Recap – *possible DQW improvements towards LHC*

Recap – possible DQW improvements towards LHC

1) PORT LENGTH

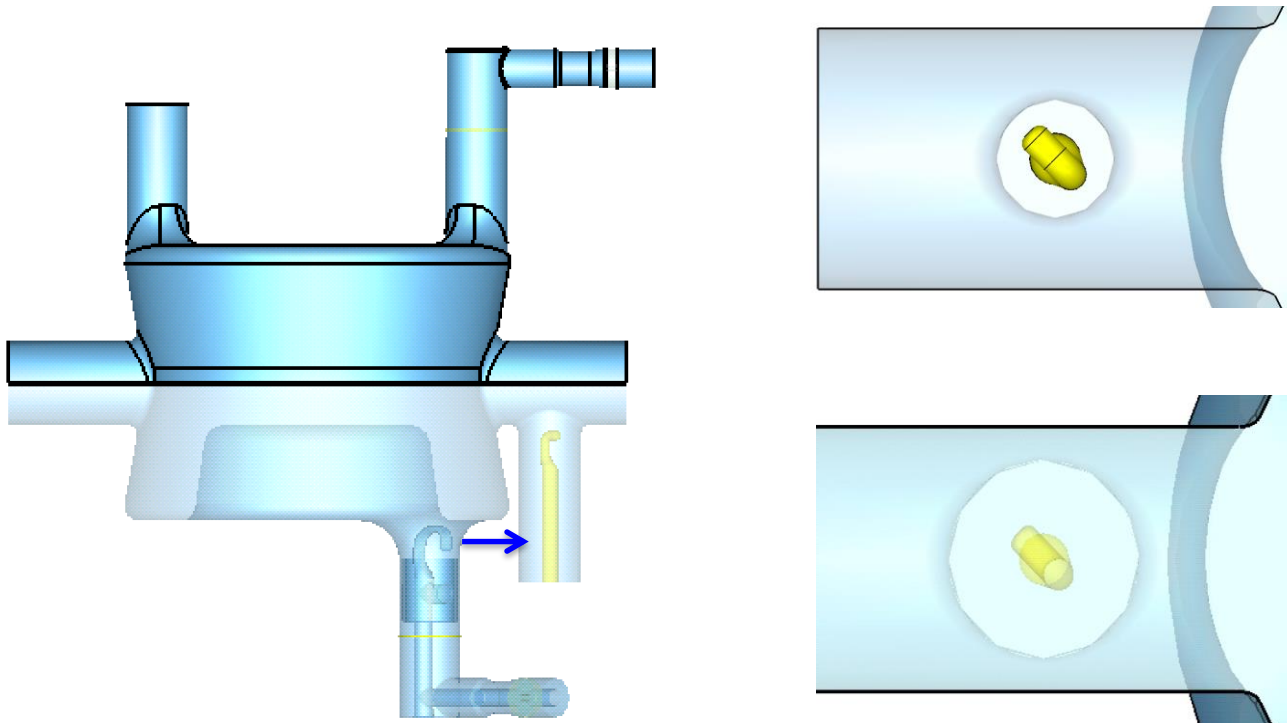
- The BP2 flange does to need to be coated (Q for non-coated BP2 is about $3e12$).
- Current cavity requires Nb-coated SS flange in BP1 to reduce losses during cold tests.

➔ Make both beam pipes symmetric – that is, beam pipe length = 349.8 mm

- EN-MME: check integration issues
 - Upload “power dissipated by Joule effect summary” in EDMS
-
- Main heat load in cold tests comes from the current test input probe ($Q \sim 4e11$).

Actions:

- Review test input probe to reduce losses
